A303 Amesbury to Berwick Down

**8.46 – Response to English Heritage objection to PRow to
Visitor Centre**

Response to English Heritage objection to PRow to Visitor Centre

Regulation Number:	Regulation 5(2)(q)
Planning Inspectorate Scheme Reference	TR010025
Application Document Reference	8.46
Author:	A303 Amesbury to Berwick Down Project Team, Highways England

OPTION E - UNCONTROLLED CROSSING

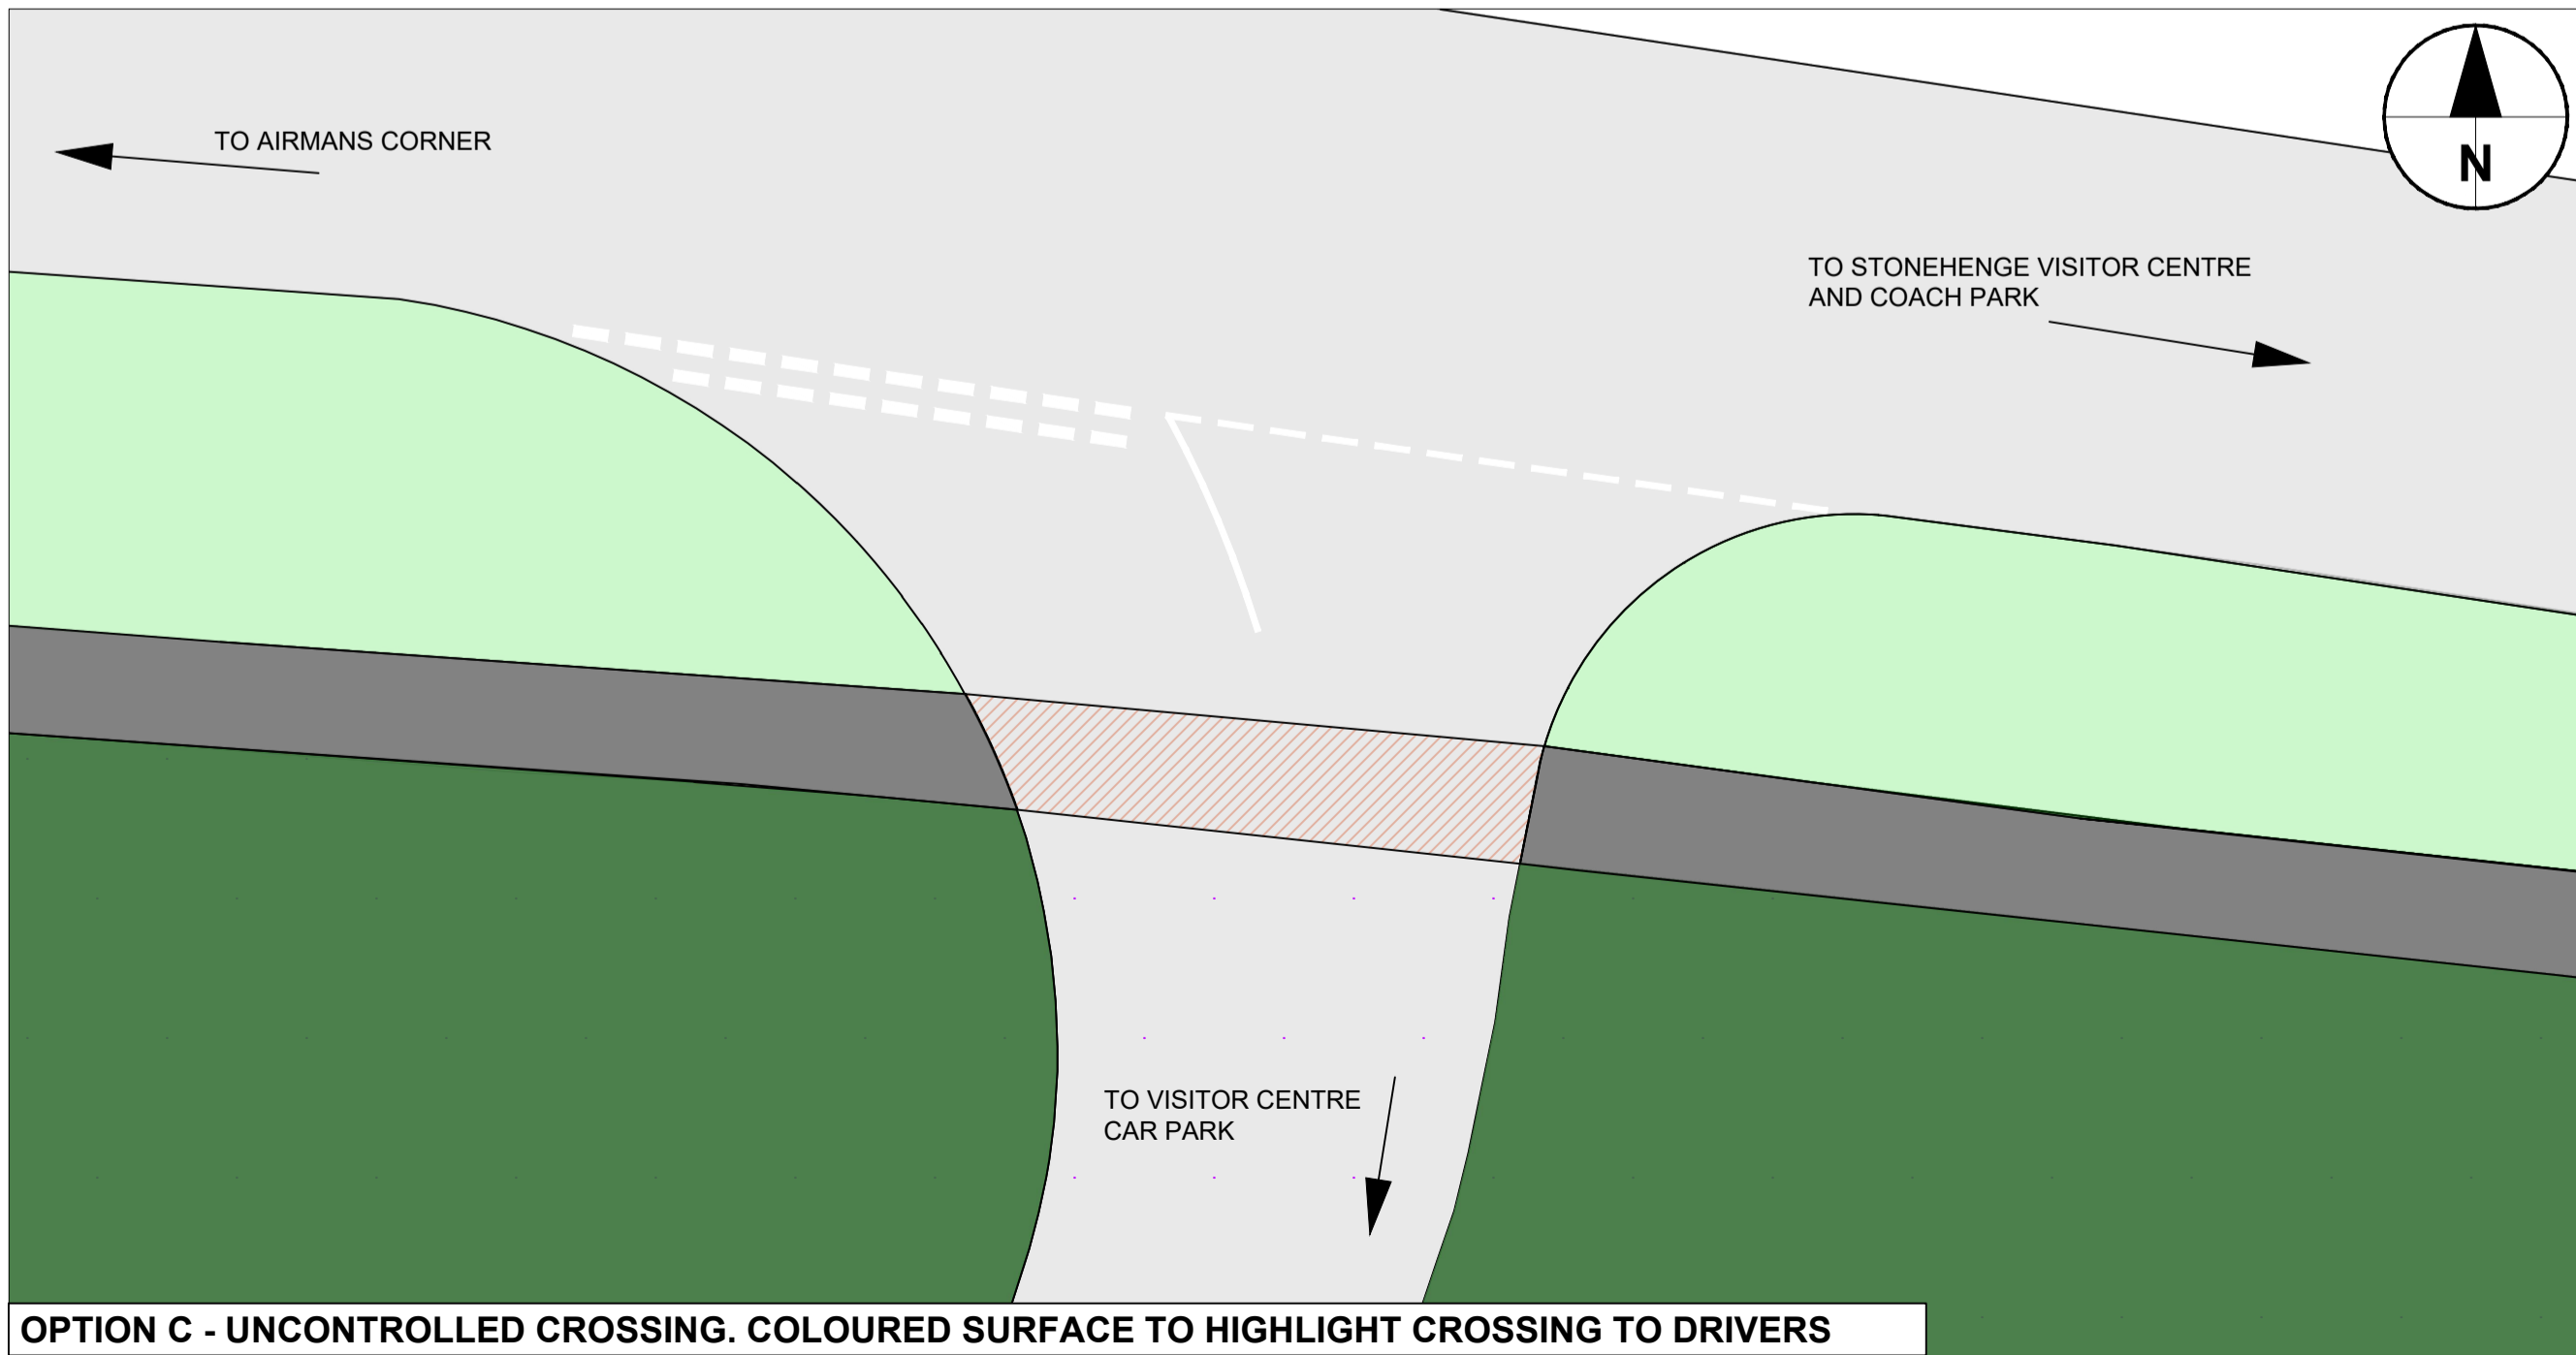
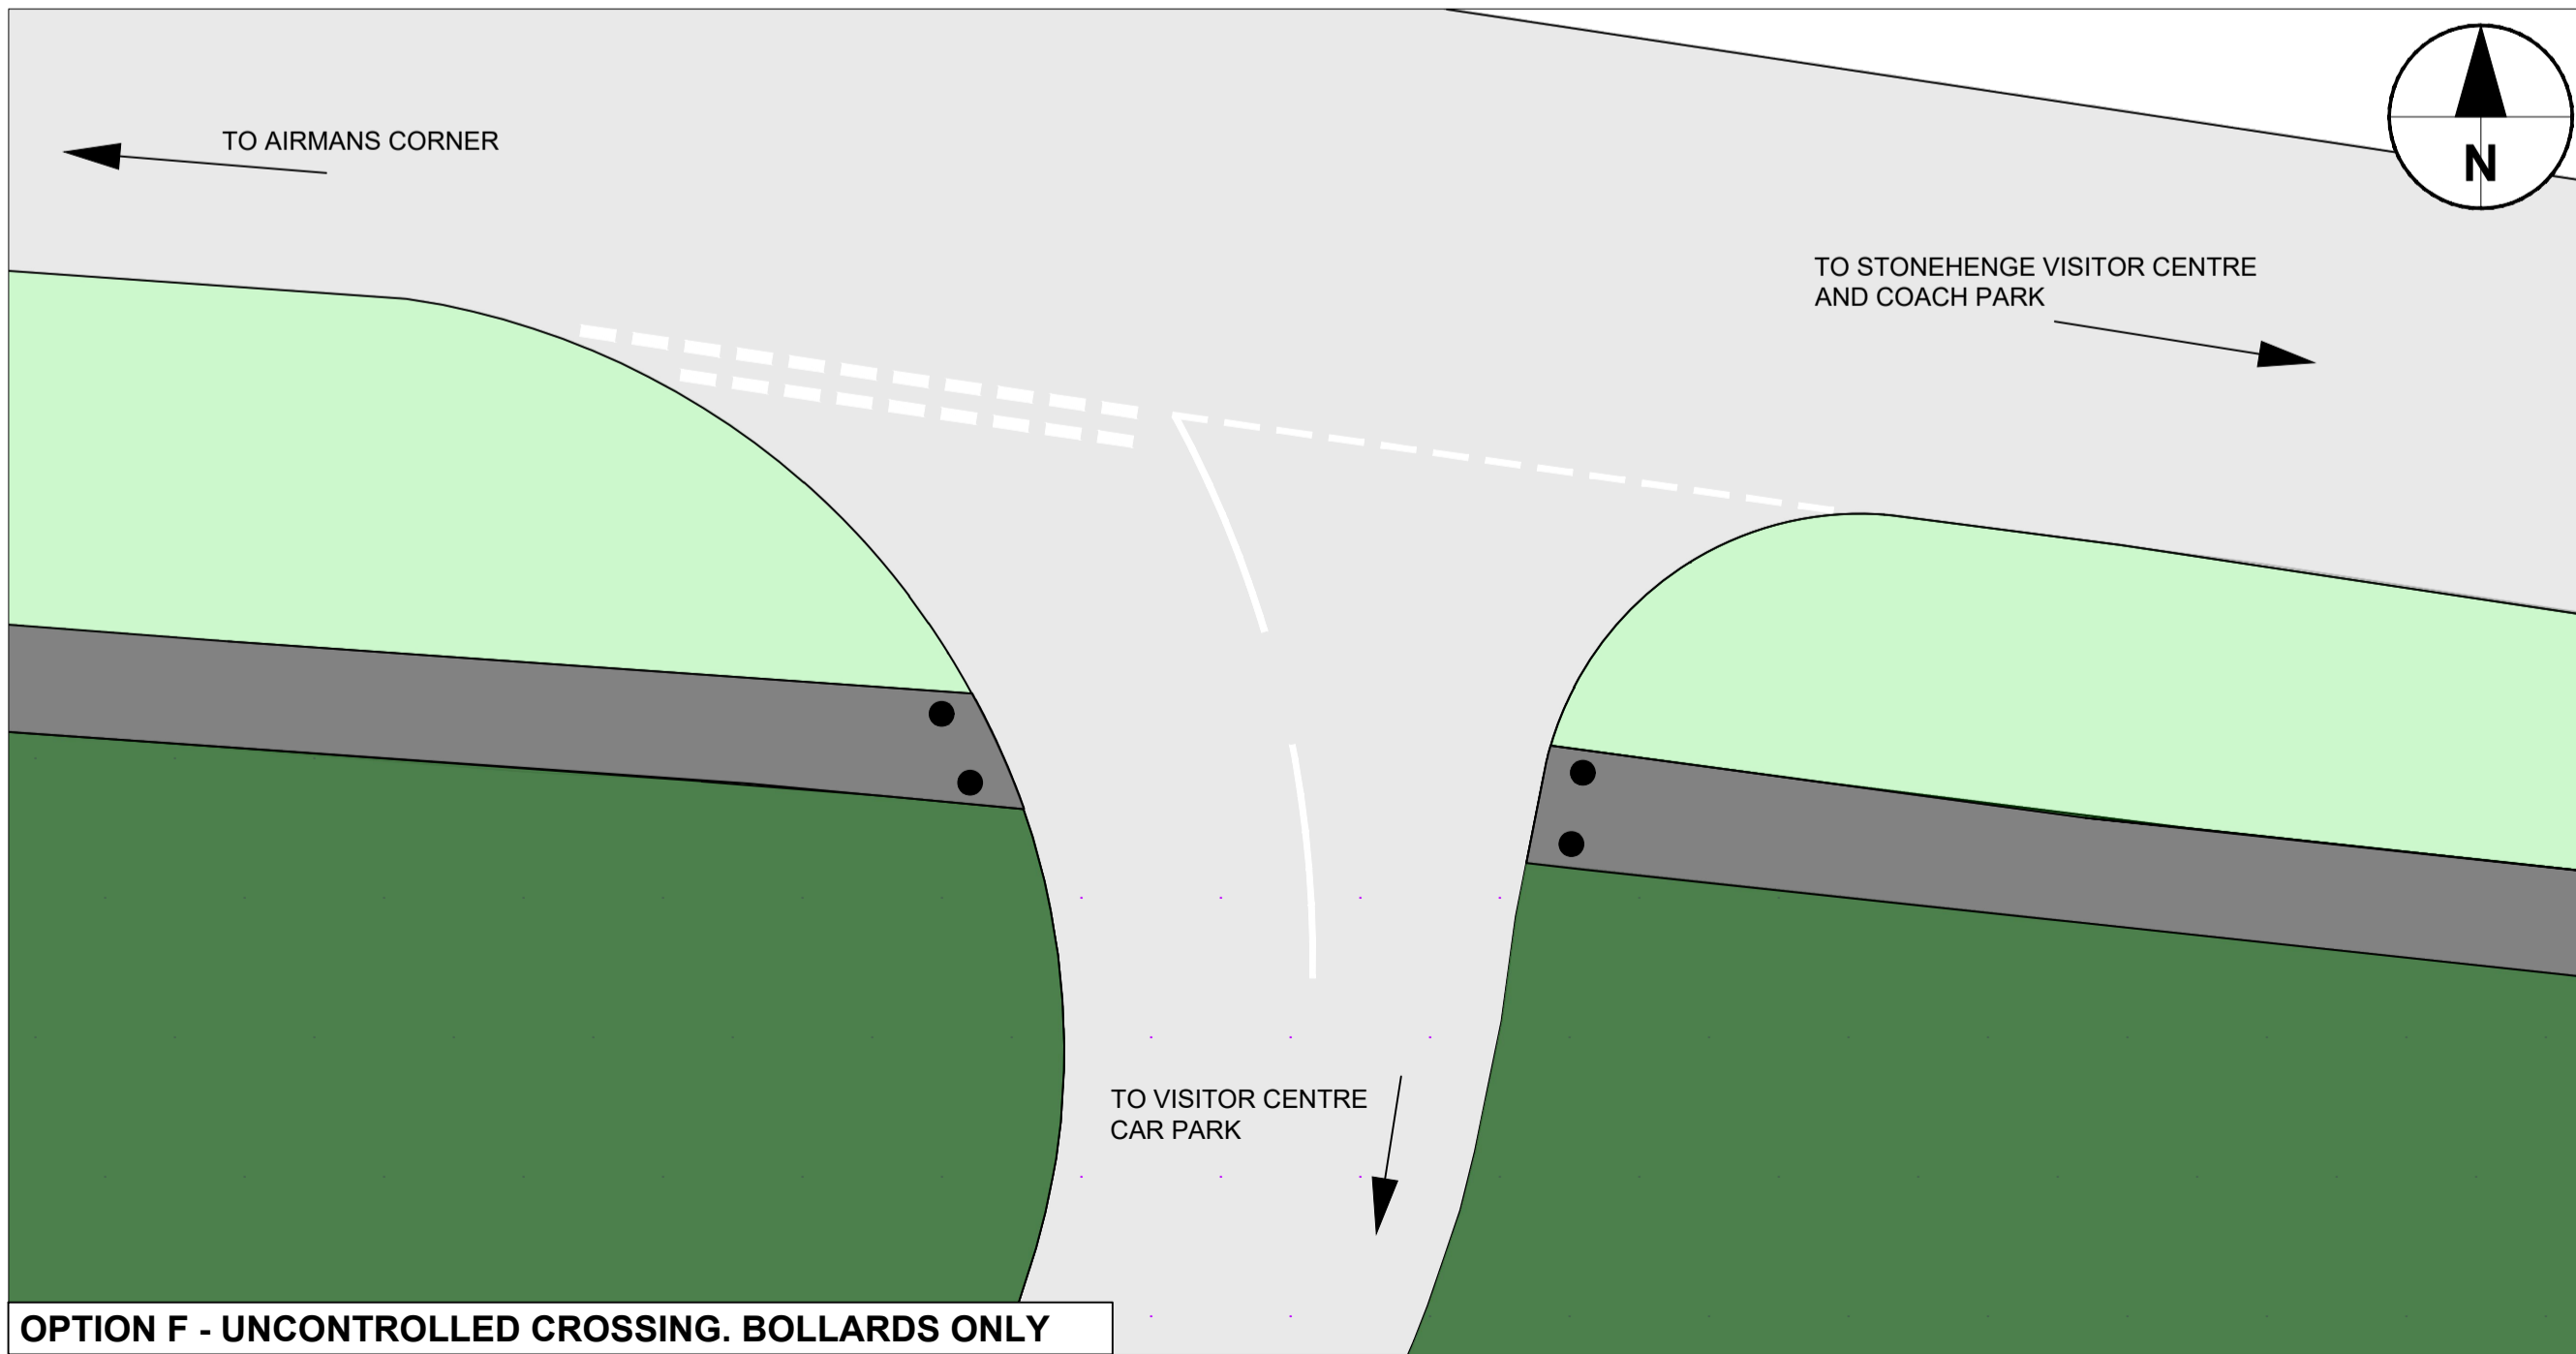
- 7.3.3 At the car park access road crossing, a number of options have been developed. Each one gives priority to the vehicles entering the car park. These options are illustrated in drawing No HE551506-AMW-ENM-SW_GN_000_Z-SK-CH-0017. See Appendix 3 to this report.
